AIRWORTHINESS DIRECTIVE

Schweizer (Hughes) 269 Series Helicopters

**AD/HU 269/57
Amdt 4**

Centre Frame Aft Cluster Fitting

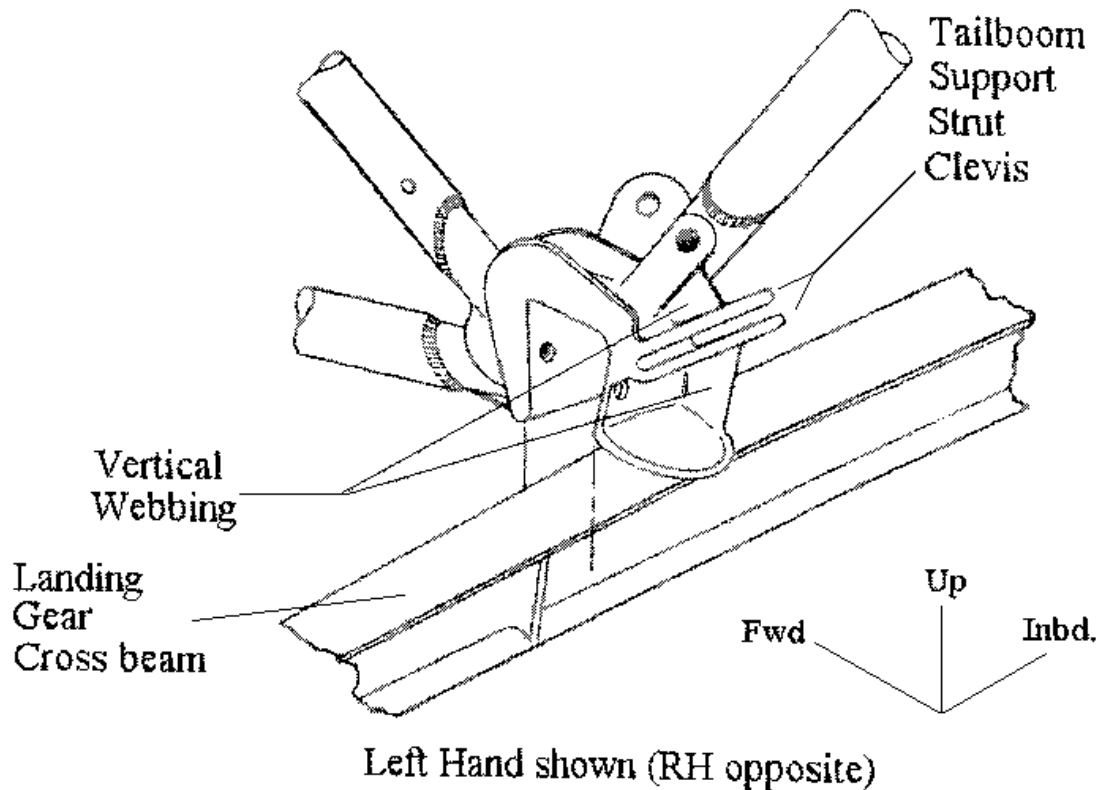
- Requirement:**
1. Accomplish the following:
 - a. Chemically remove paint from the clevis lugs on each centre frame aft cluster fitting. Wash with water and dry.
 - b. Dye-penetrant inspect the clevis lugs on each aft cluster fitting.
 - c. If a crack is found, before further flight, replace the cracked aft cluster fitting with a serviceable part number 269A2234-3 or 269A2235-3 aft cluster fitting, as applicable.
 - d. If no cracking is found, clean the aft cluster fitting and repaint.
 2. Replace each aft cluster part number 269A2234 and part number 269A2235 not modified in accordance with Kit part number SA-269K-106-1 with part number 269A2234 and 269A2235 aft cluster fittings modified in accordance with Kit part number SA-269K-106-1; or with aft cluster fittings part number 269A2234-3 and 269A2235-3.
